Docket Item # 5
BAR CASE # 2011-0001

ISSUE: Change to previously approved plans for windows Phase I, James Bland Redevelopment

LOCATION: 808 Madison Street

Figure 1. Model unit, 735 North Columbus Street, with painted CPVC window on left and painted wood window on right.

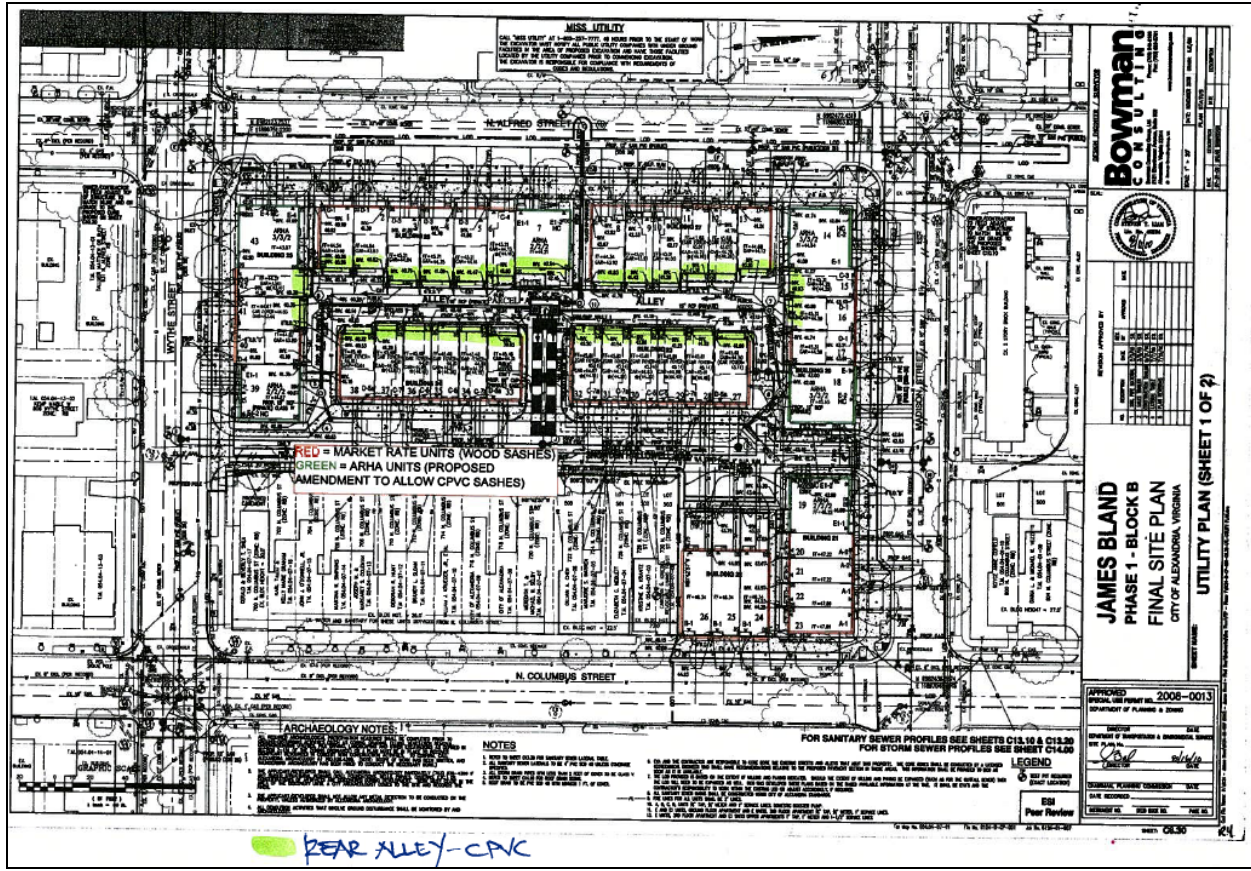
The applicant had specified MW Jefferson simulated divided light wood frame and sash windows with a CPVC brickmould and sill. Upon inspection of the first townhouses constructed, Staff observed that the window sash were also CPVC, rather than the approved wood. Staff met with the applicant to discuss this issue and informed the applicant that Certificates of Occupancy would not be issued until action was taken to correct this issue. The applicant placed a rush order to replace the window sash on the front and side elevations of the market-rate units and submitted a BAR application to allow for the CPVC windows on the ARHA units as well as the rear (alley-facing) elevations of the market-rate units (see diagram).

According to the applicant, the installed windows are the Ply Gem MW Pro Series 400 which are identical to the wood windows except the sashes are solid, paintable CPVC instead of wood. The applicant indicated that the installed windows were more expensive than the wood windows and that cost was not a motivating factor.

The applicant has submitted a BAR application for approval of a change in window material for the ARHA units and the rear elevations of market-rate units visible from the alley. Staff explained to the applicant that the newly-adopted Window Policy clearly states that vinyl is not appropriate. Although CPVC is a material relative of vinyl (PVC, among other forms), the CPVC window has distinct differences from the typical vinyl window. Whereas, a typical vinyl window is hollow, difficult to paint and ages poorly, CPVC is a solid-through-the-core, millable and paintable material. While we do not know how this CPVC window will weather and age over time, CPVC has been used with success for trim, cornices and railings for several decades.

In conclusion, Staff cannot recommend approval of CPVC windows on any units in Phase I, as the proposed material is not considered appropriate in accordance with the Window Policy and the *Design Guidelines*. However, the Board has the ability in the Window Policy to contemplate the circumstances of each application on a case-by-case basis, taking into consideration the age of the building, the location of the proposed change, the economics of the different material, and the exploration of alternate materials that may be appropriate in certain specific circumstances in some defined areas of the district.

STAFF RECOMMENDATION: Staff recommends denial of the submitted application.
